**Supporting Works for Section 16
Application for operating a
Temporary Open Storage and
Maintenance Workshop in Lots
401(Part), 404(Part), 405 RP(Part),
406 RP, 408 RP (Part), 409 and
410(Part) in D.D. 106, Pat Heung,
Yuen Long, New Territories**

Drainage Proposal

Reply to Comment

Application No. A/YL-KTS/957

| DRAWING TITLE: PROPOSED CATCHMENT AREA | |

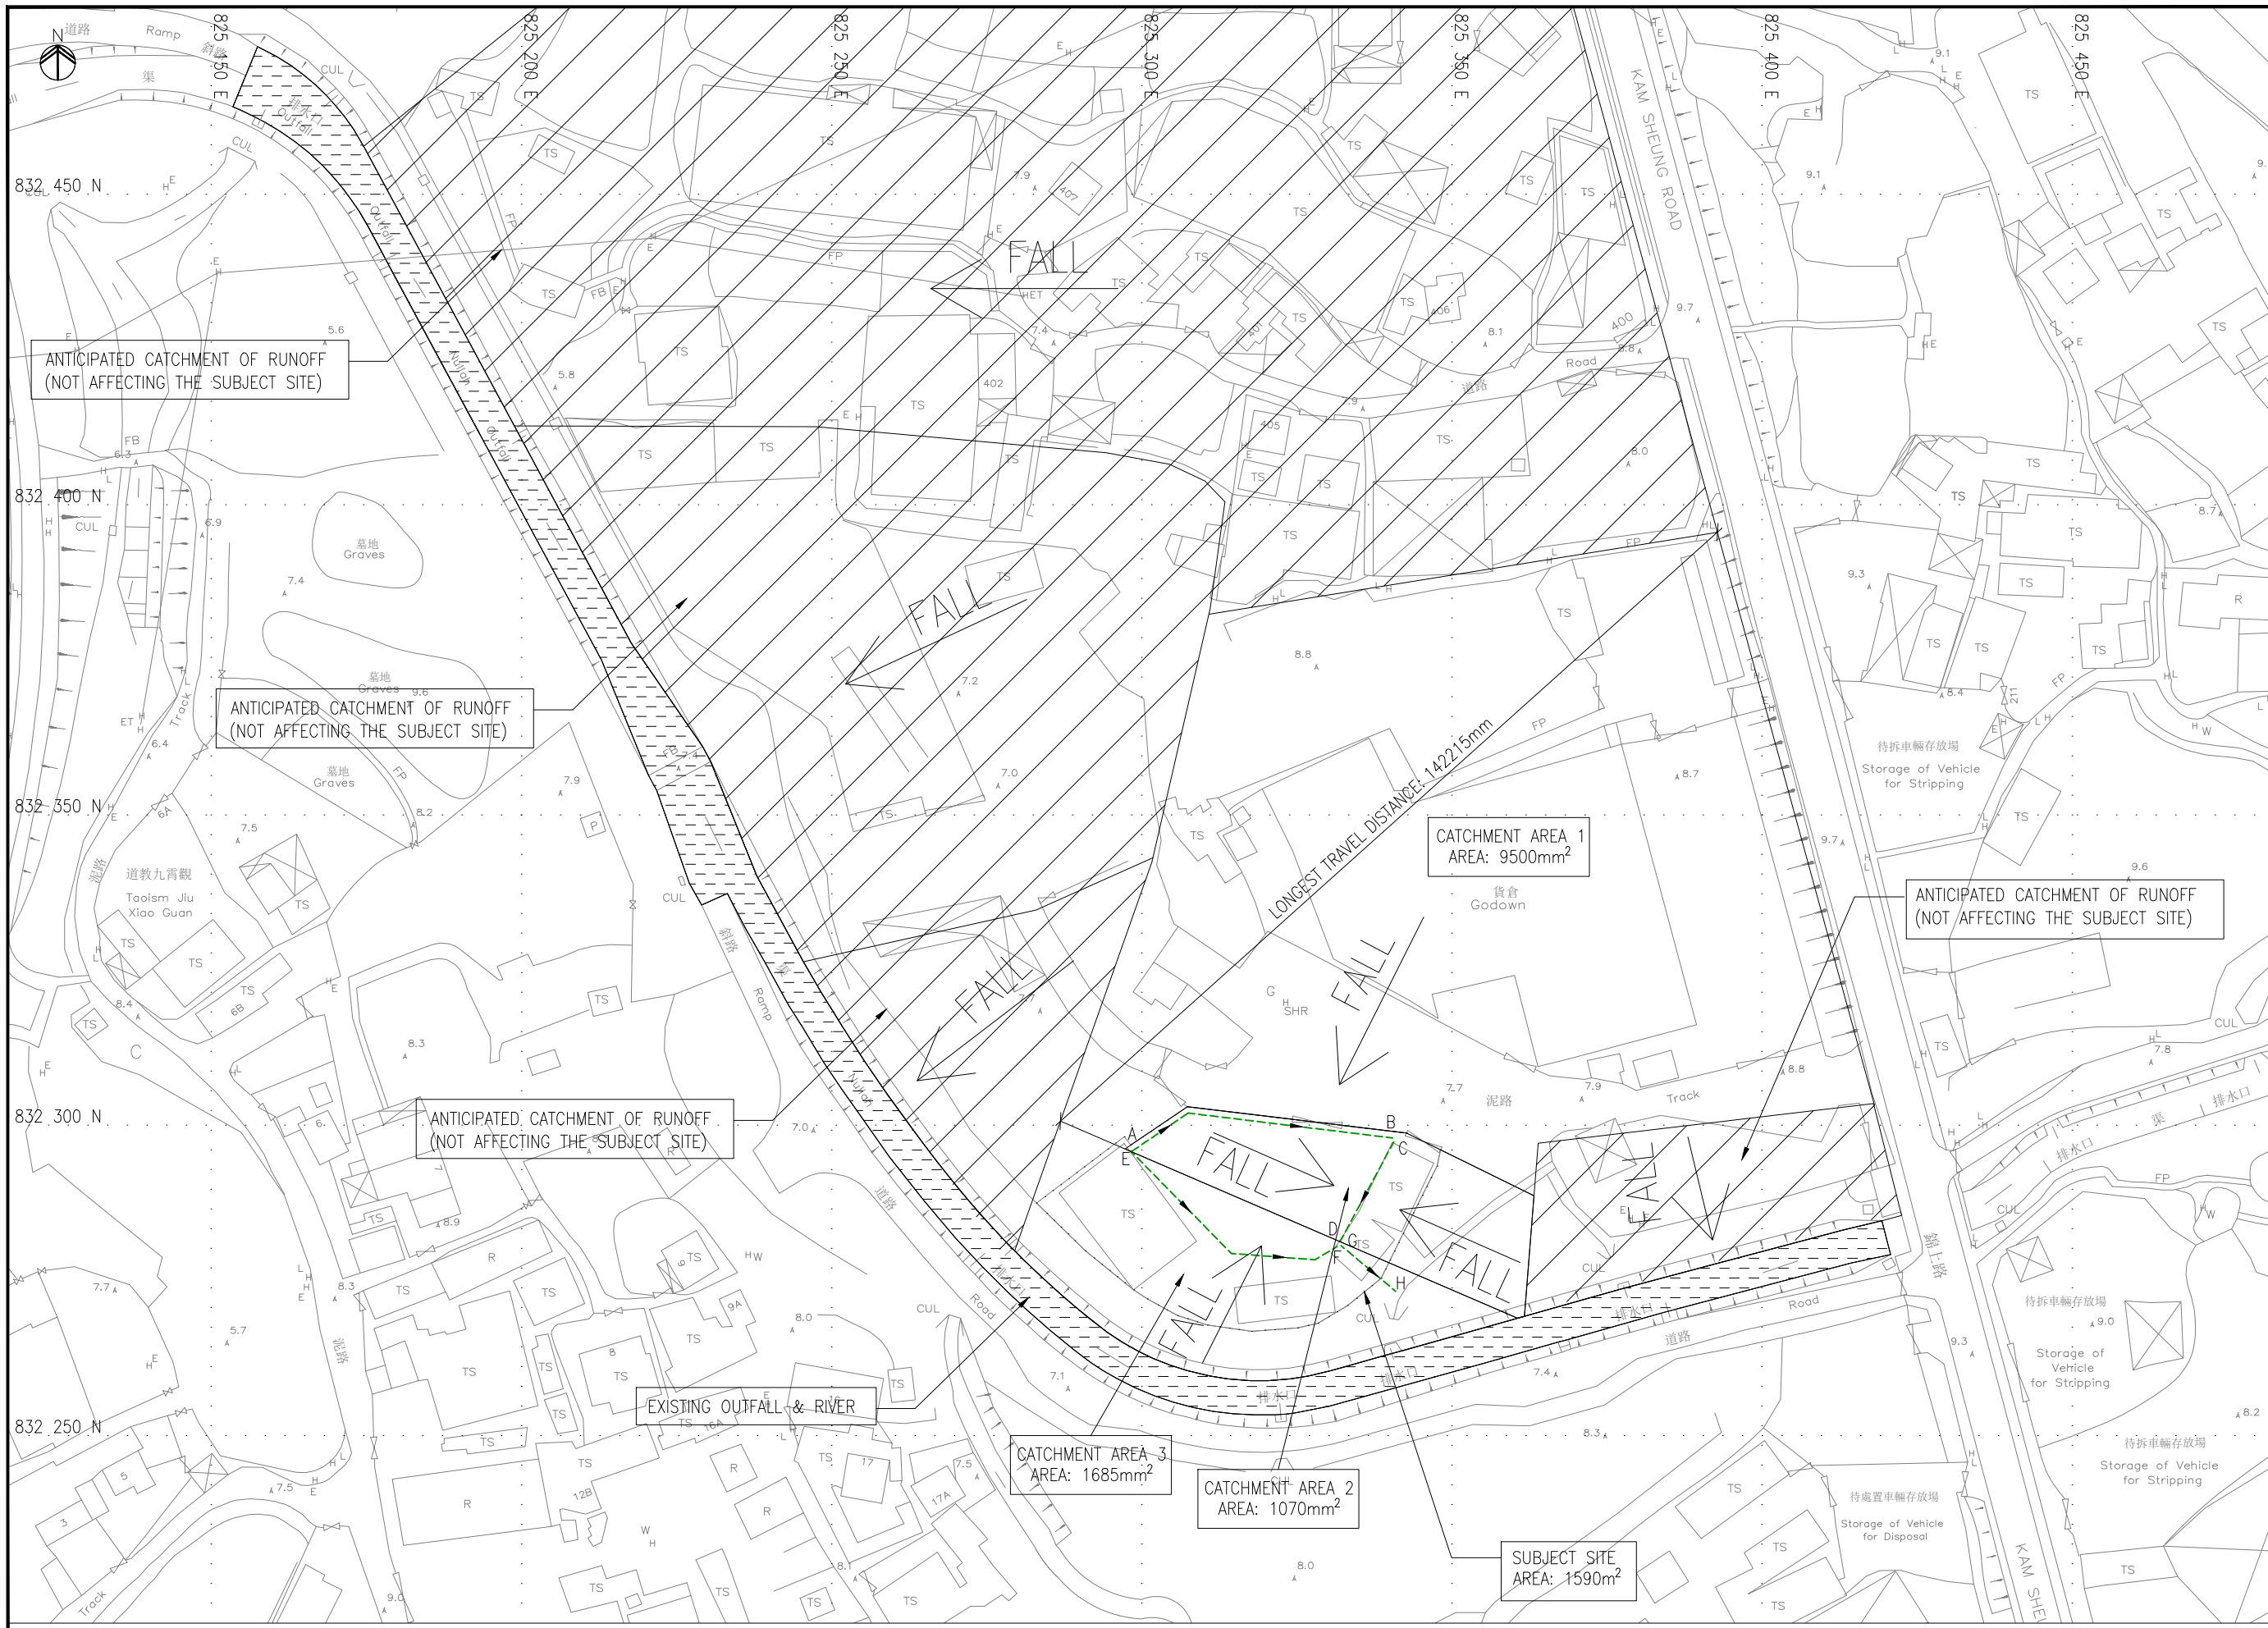
| | Comment from DSD | Responses |
|----|--|--|
| 1) | The ground to the east and north of the application site are generally higher. Since the overland flow from the adjacent lands shall be probably intercepted, external catchment shall be considered in the calculation. | - External catchment area has been considered in the runoff calculation and checking of drainage system. The calculation is attached in this submission. |

| DRAWING TITLE: LAYOUT PLAN COMBINED WITH DRAINAGE PLAN | | |

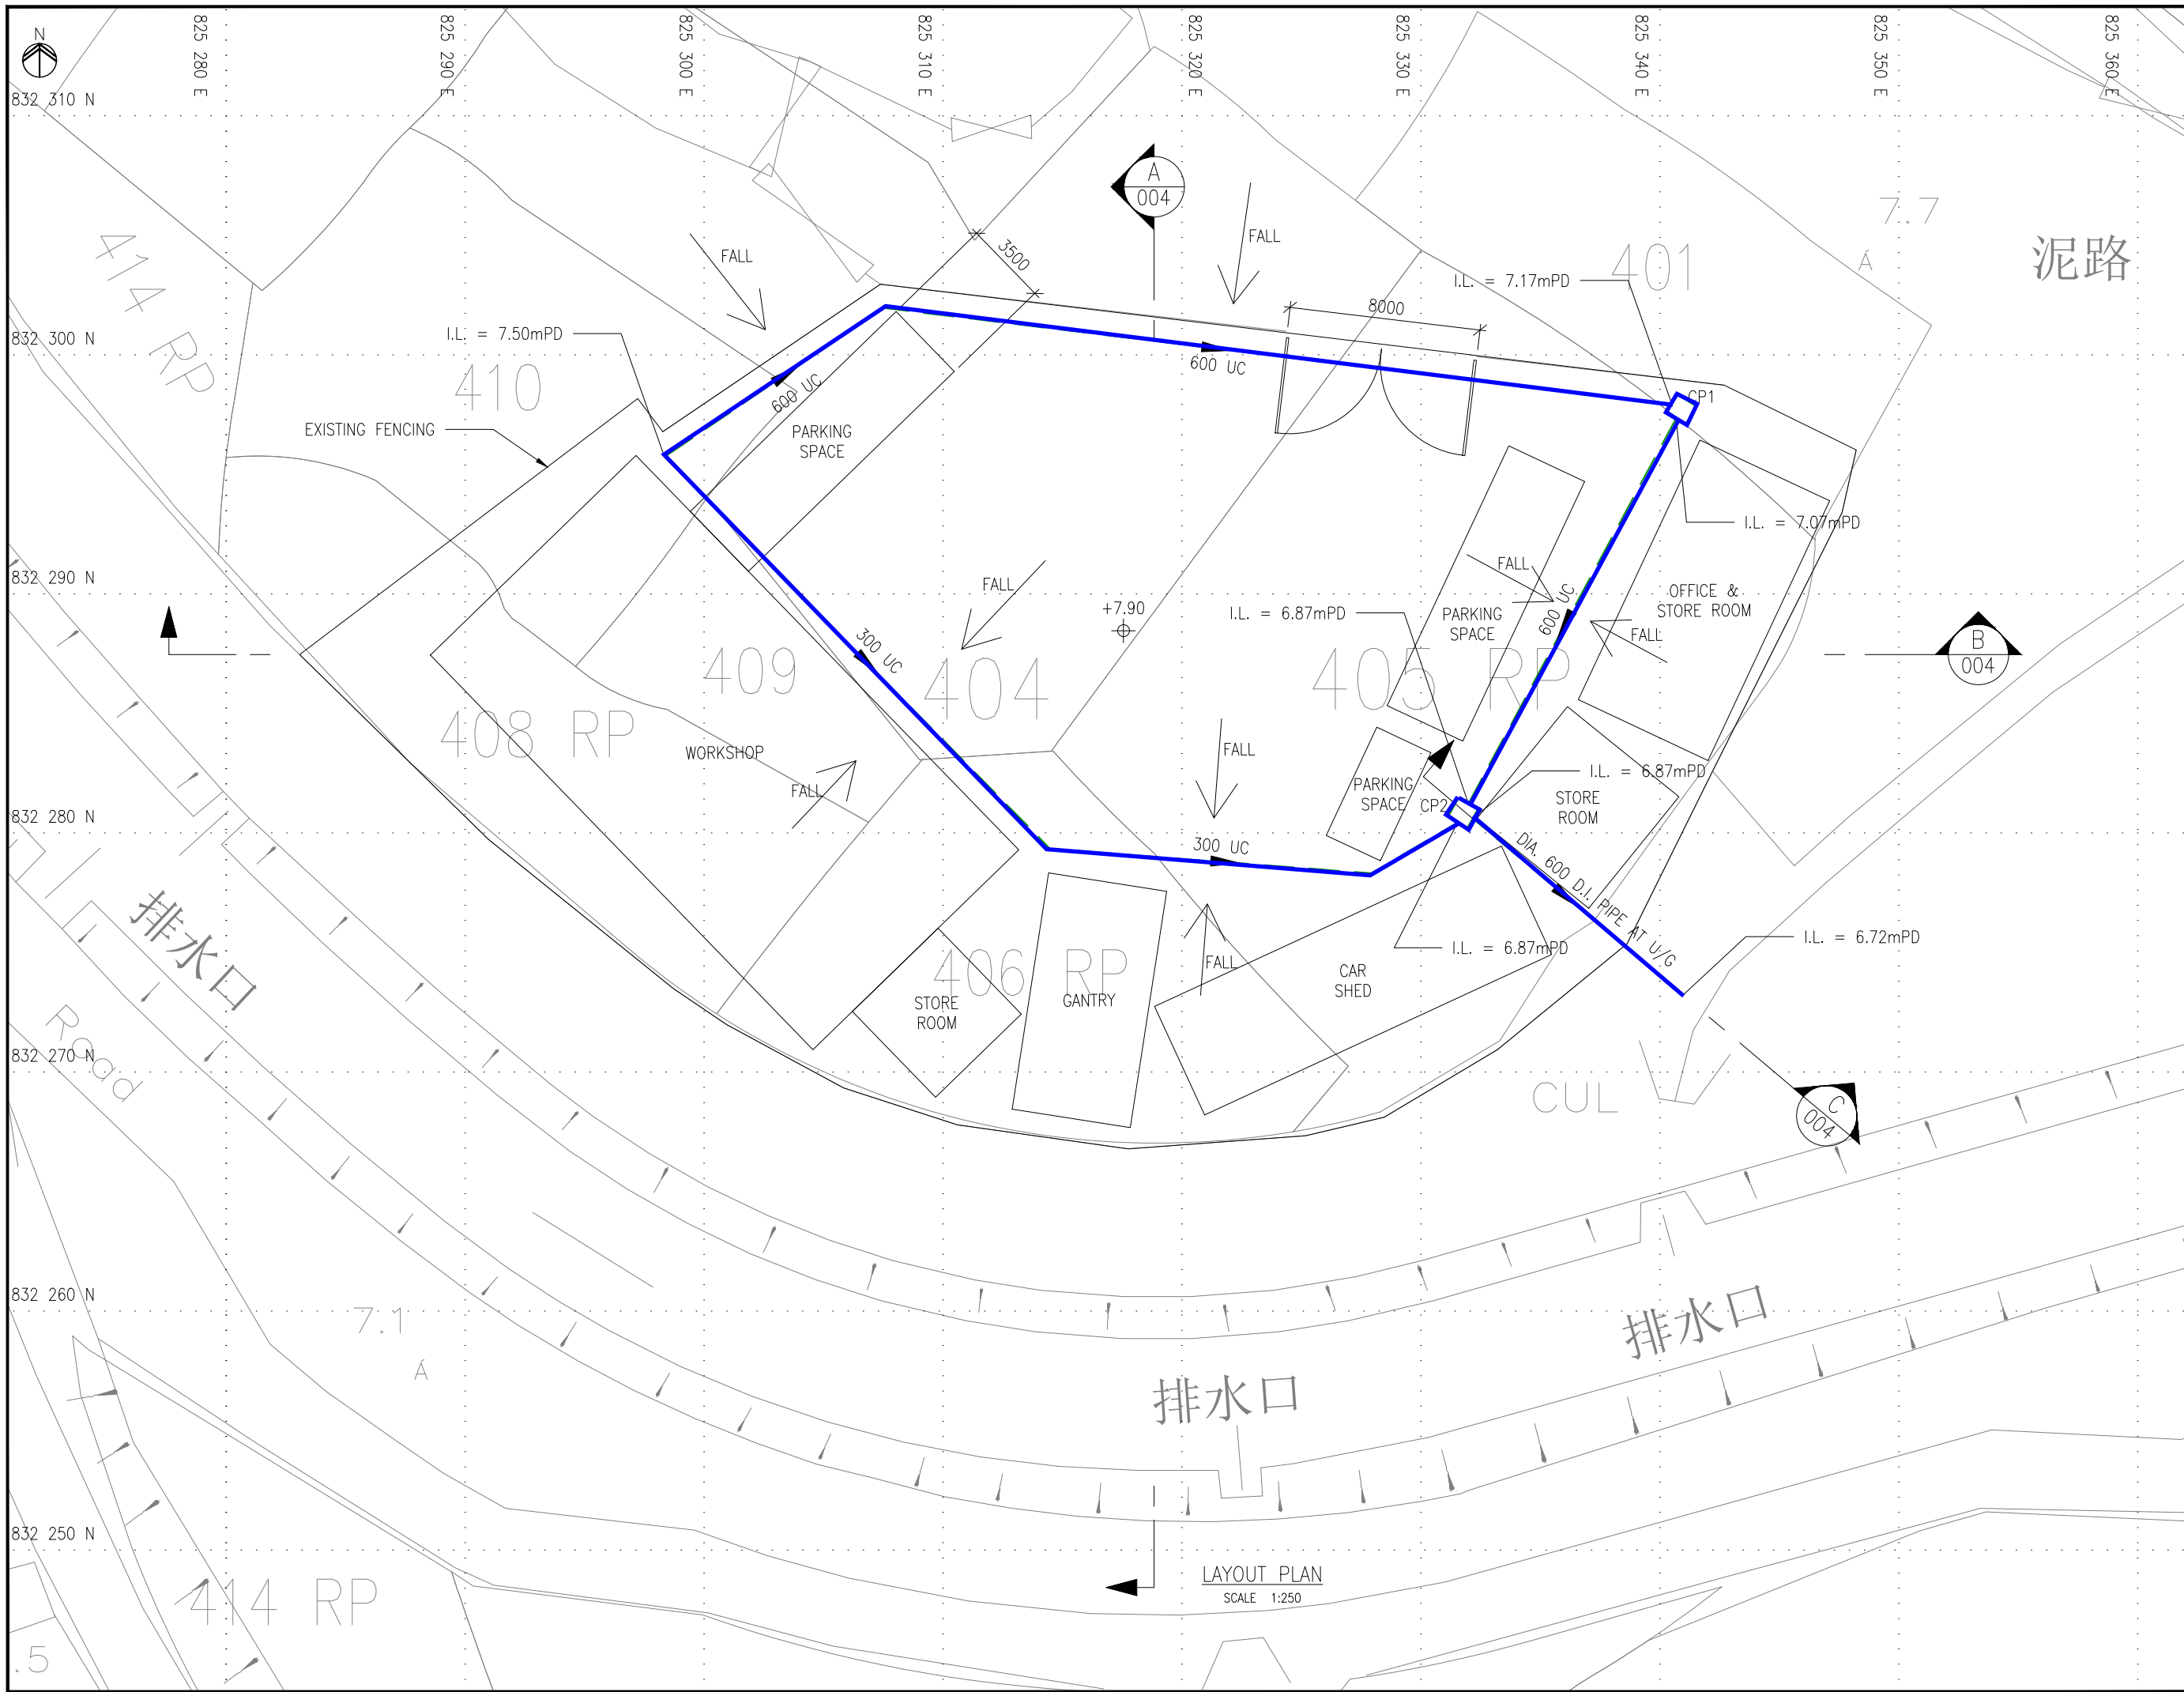
| | Comment from DSD | Responses |
|----|--|--|
| 4) | The gradients and the sizes of the proposed U-channels should be shown on the drainage plan. | - The gradients and the sizes of the proposed U-channels have been shown on the revised drainage plan. |

| 5) | Please clearly indicate the details of openings (e.g. size, arrangement, etc.) to be provided to intercept the existing overland flow passing through the site on the drainage plan/cross section drawings. | <ul style="list-style-type: none"> - Details have been provided on the revised drawings. - The fencing provided clearance (min. 50mm) above ground level to intercept the existing overland flow passing through the site |

Site Photos

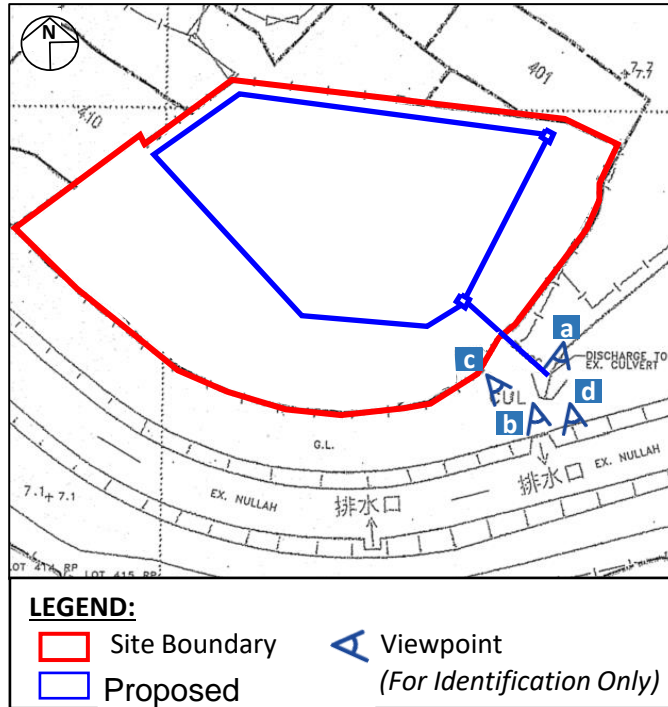
| 7) | Further to (6) above, since there is no record of the said discharge path, please provide site photos to demonstrate its presence and existing condition. | <ul style="list-style-type: none"> - Site photos have been provided in Appendix of the drainage proposal. |
